**TOWN OF TUNNELTON MUNICIPAL SEWER WORKS
PRESTON COUNTY, WEST VIRGINIA**

**PHASE II – 0.04 MGD WASTEWATER TREATMENT PLANT AND COLLECTION
SYSTEM UPGRADES**

ADDENDUM #1

AUGUST 24th, 2022

SHEET No.
22

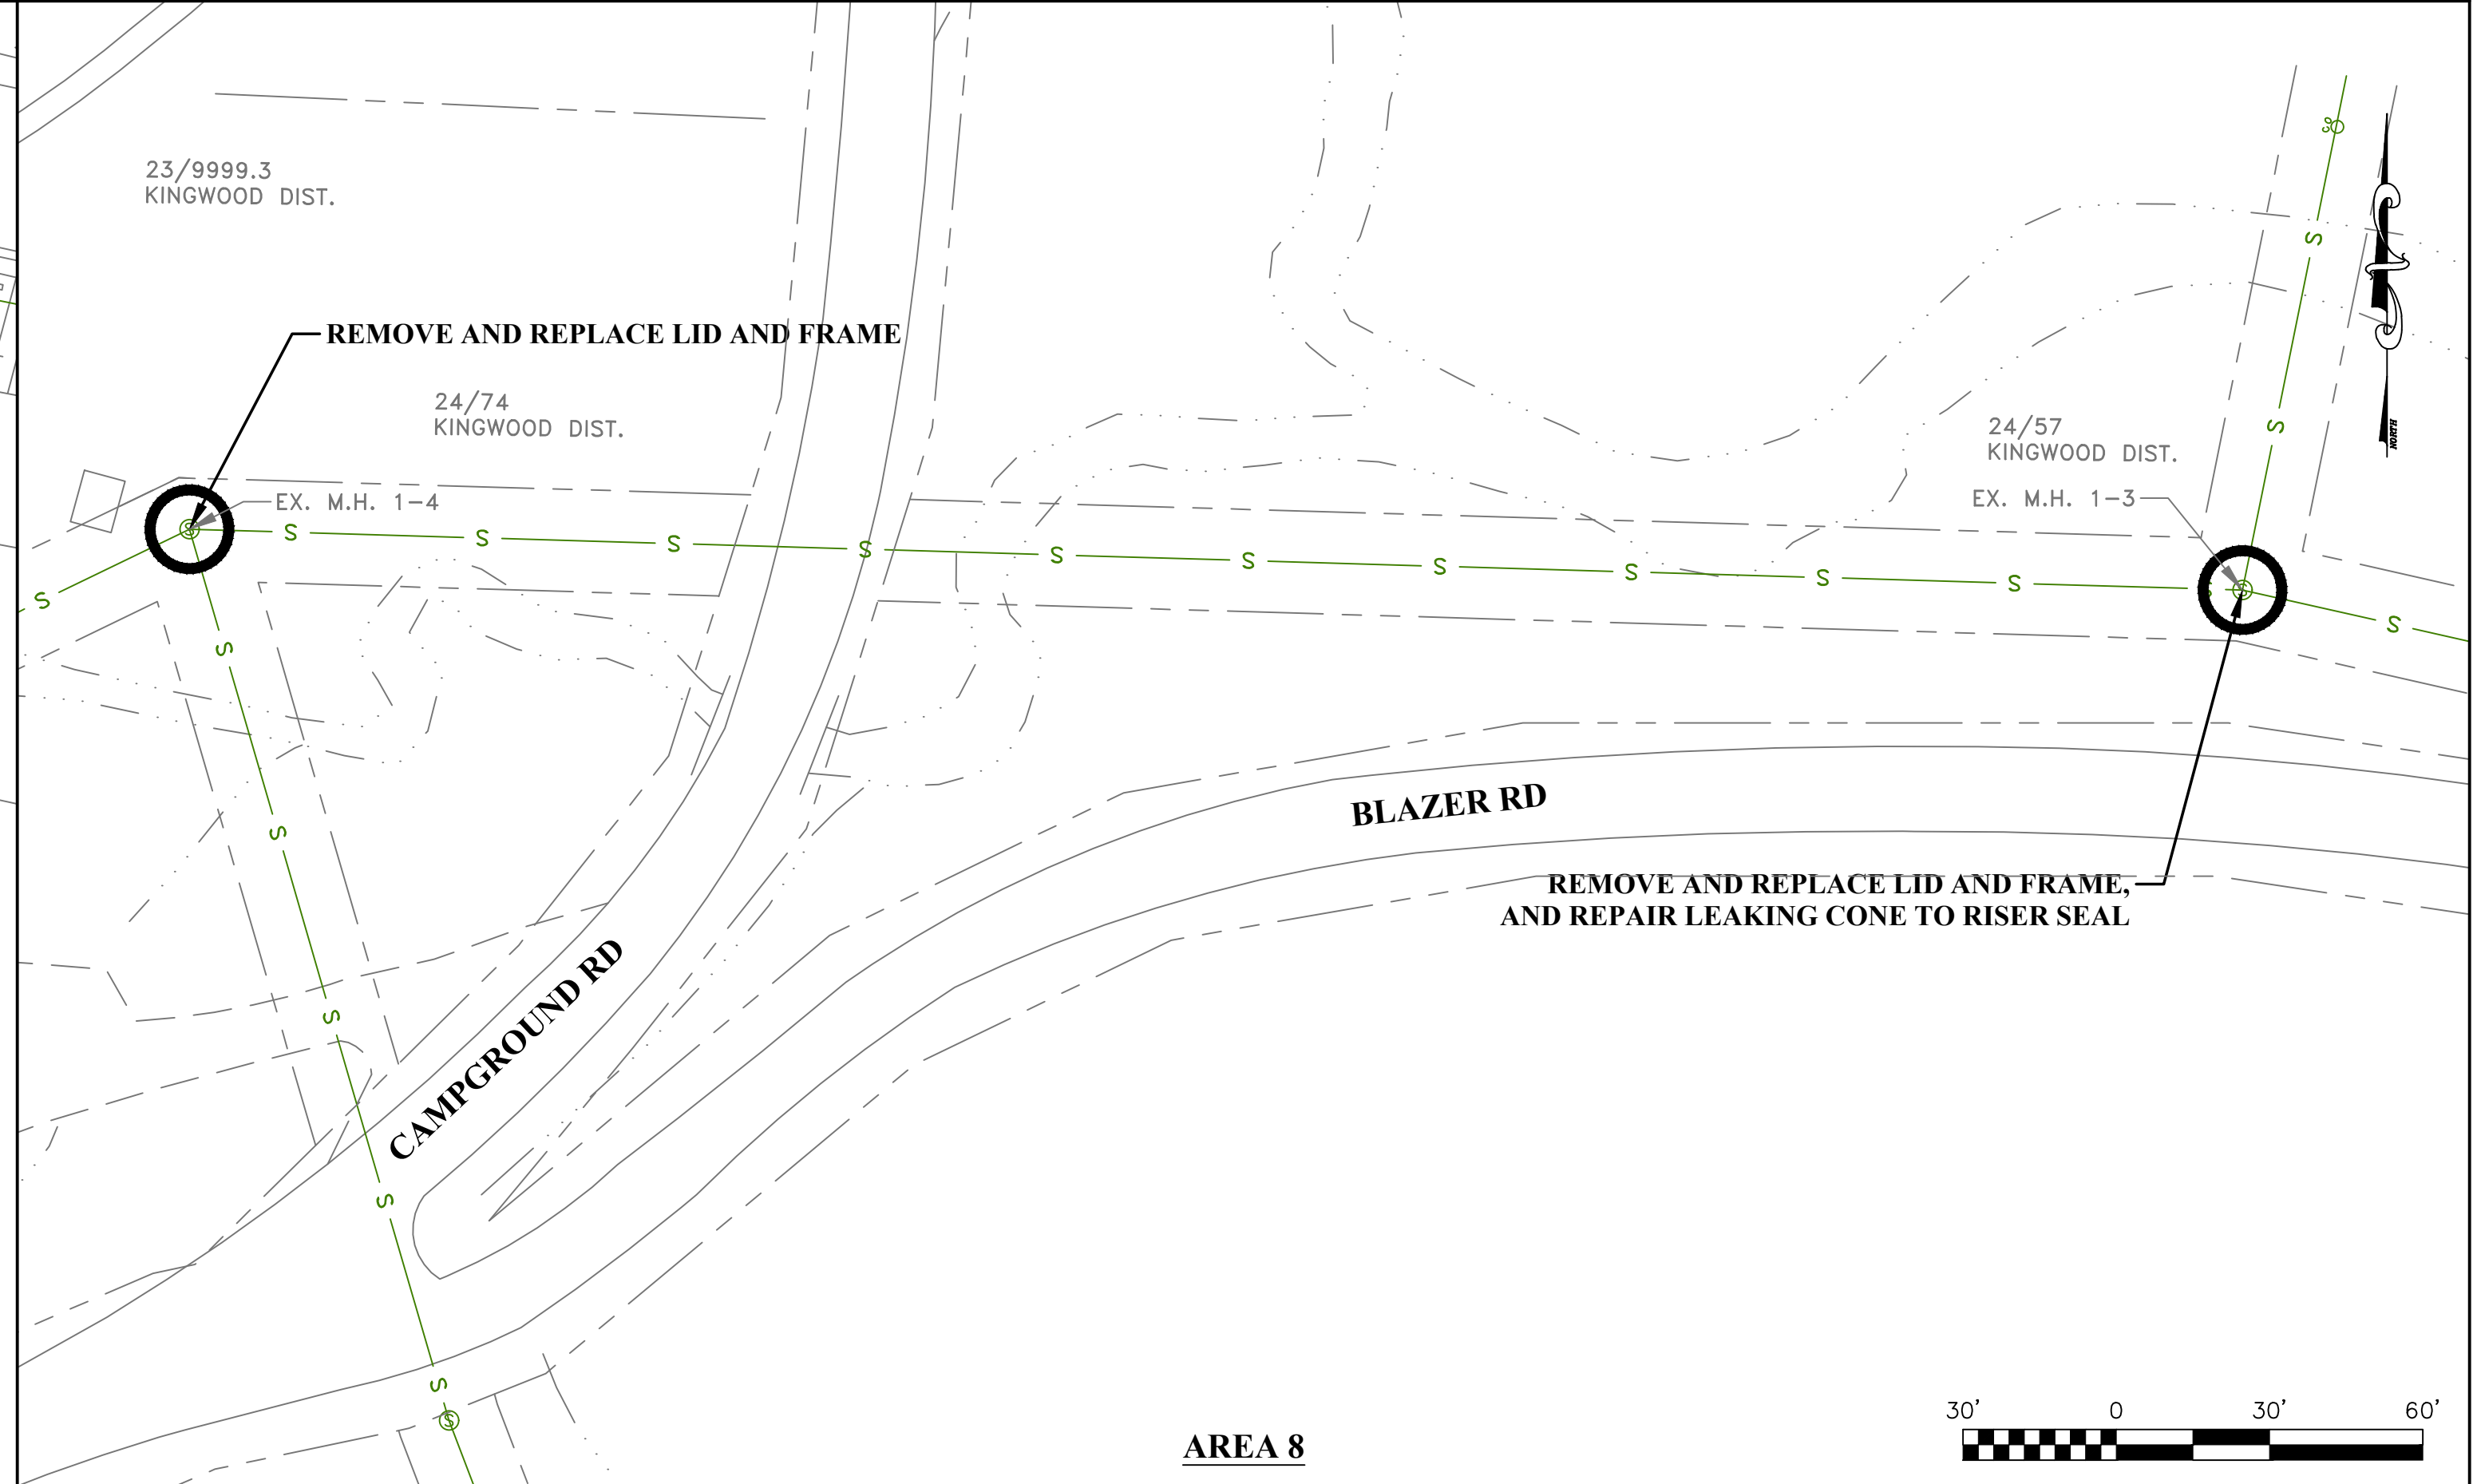
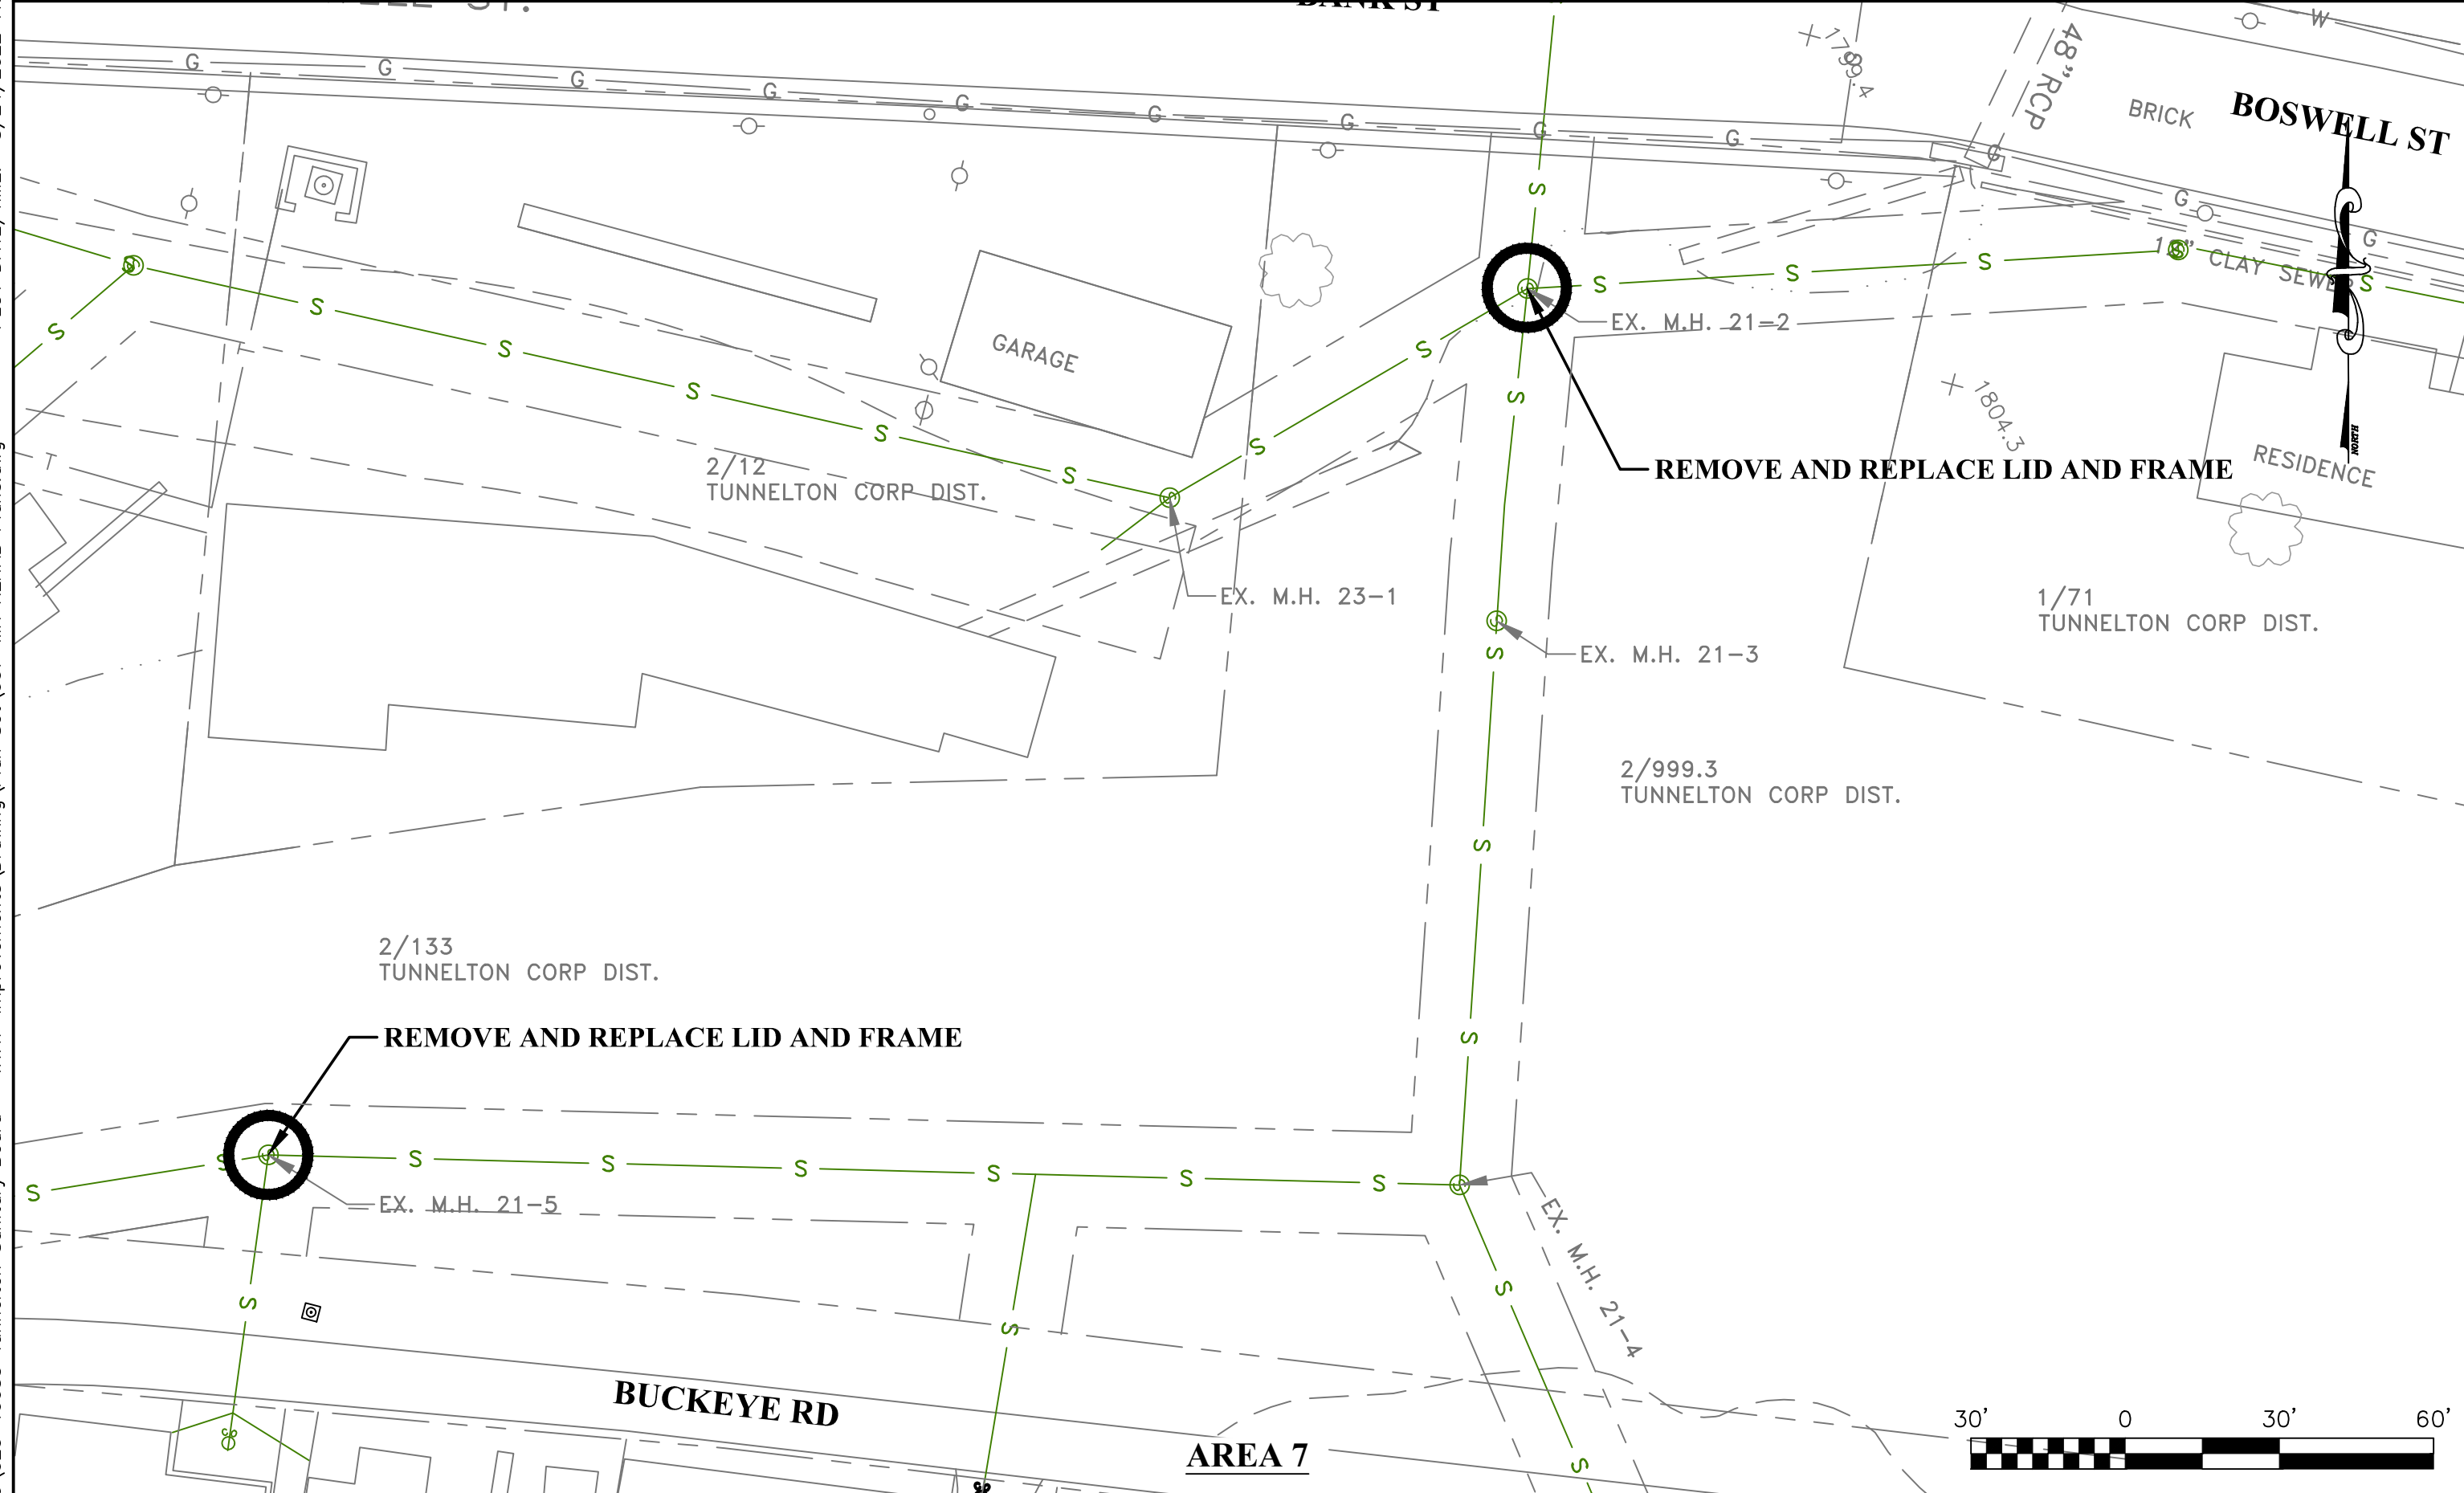
5. Sheet 22 indicated that line 24 of Area 6 is to be capped. This is shown in the middle of the roadway. Can the invert of line 24 be plugged inside the downstream manhole or can the capping indicated be performed closer to Manhole #23-3? Also, what is the depth of the sewer lines to be capped?

Line 24 is to be capped to the south of South St. along the alignment. The line depth at this location is approximately eight feet. Plan Sheet 22 has been revised as part of this Addendum.
